# Access Compliance Report

## Public Rights-of-Way

### (Curb Ramps)

Intersection ID: 10041631	Main Street: WHITEHALL_PARK_DR	Cross Street: N/A	Location: SE
ADA ID: 62843F33AF05	Ramp Type: ParaDiag	Initial Pass/Fail: Fail	Overall Compliance: No
Severity Score: 12.5			
Codes/Mitigation Info/Possible Solution		Field Measurements/Component Compliance

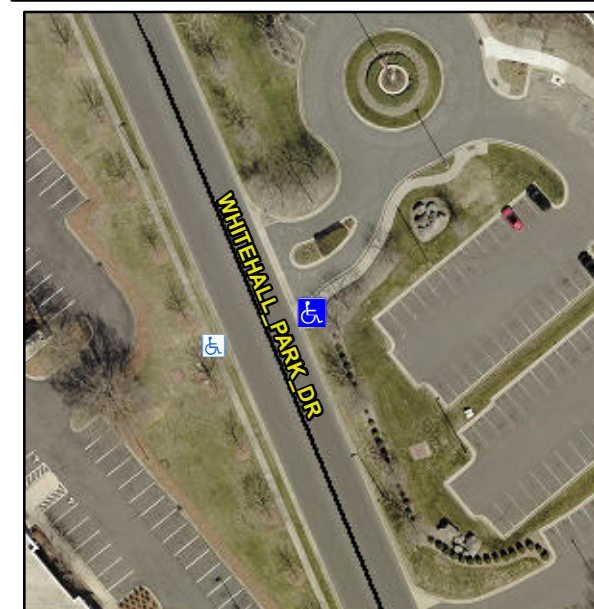
**LT RP < 5%**

**R304.3.2**

Compliance	Description	Data	Compliance	Description	Data
N/A	Ramp Length LT (in)	79.0	N/A	Ramp Length RT (in)	51.0
Yes	Ramp Width LT (in)	60.0	Yes	Ramp Width RT (in)	60.0
Yes	Ramp Slope LT (%)	0.9	No	Ramp Slope RT (%)	8.7
Yes	Ramp XSlope LT (%)	1.8	Yes	Ramp XSlope RT (%)	1.5
N/A	Landing Length (in)	N/A	N/A	DWS Provided?	N/A
N/A	Landing Width (in)	N/A	N/A	DWS Contrast?	N/A
N/A	Landing Slope (%)	N/A	N/A	DWS Length (in)	N/A
N/A	Landing X Slope (%)	N/A	N/A	DWS Full Width?	N/A
N/A	Landing Curb? (Y/N)	N/A	N/A	DWS Offset (in)	N/A
N/A	Shared Landing?	N/A			
N/A	Gutter Ponding?	N/A	N/A	Gutter Slope (%)	N/A
N/A	Gutter Lip Ht (in)	N/A	N/A	Gutter X Slope (%)	N/A
N/A	Painted X Walk1?	No	N/A	Painted X Walk2?	No
	X Walk 1 Direction	To NW		X Walk 2 Direction	To SW
N/A	X Walk 1 Width (in)	N/A	N/A	X Walk 2 Width (in)	N/A
	X Walk 1 Slope (%)	1.4		X Walk 2 Slope (%)	0.6
	X Walk 1 X Slope (%)	2.5		X Walk 2 X Slope (%)	0.9
N/A	Ramp inside XWalk1?	N/A	N/A	Ramp inside XWalk2?	N/A

**Remove & Replace Curb Ramp With Two New Directional Ramps or Equivalent.**
